ADDENDUM NO. 3

2020 Wastewater Treatment Plant Improvements Effluent Pump Station Rehabilitation Phase 4

CCE Project No. C0183
PEC PROJECT NO. 11557

DATE ISSUED: Monday, September 19, 2022

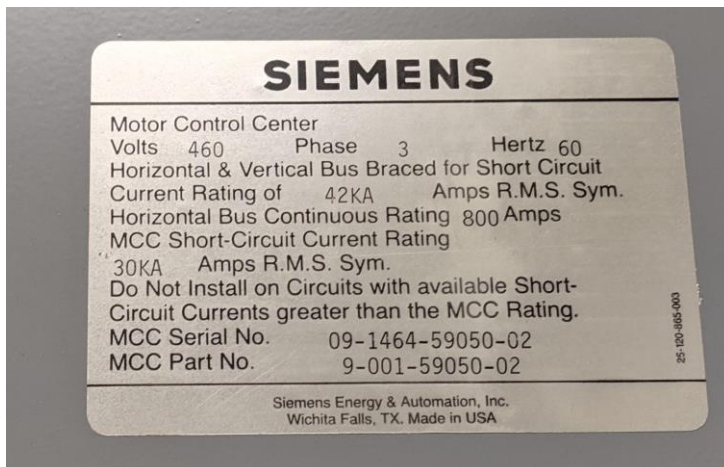
1. Contractor to plan on adding (2) 600A breakers.
2. Contractor can utilize the existing 3" conduits, Engineer can not verify condition of existing conduit.
3. Contractor is allowed to reach out to the manufacturer of the control systems. Contact is Randy Dent, office phone is (601) 355-8594, email randyd@controlsysinc.com.
4. Cabling to be used shall be what is called out in the drawings.
5. The existing MCC is Siemens (see picture below). Contractor to verify with rep for exact part number.
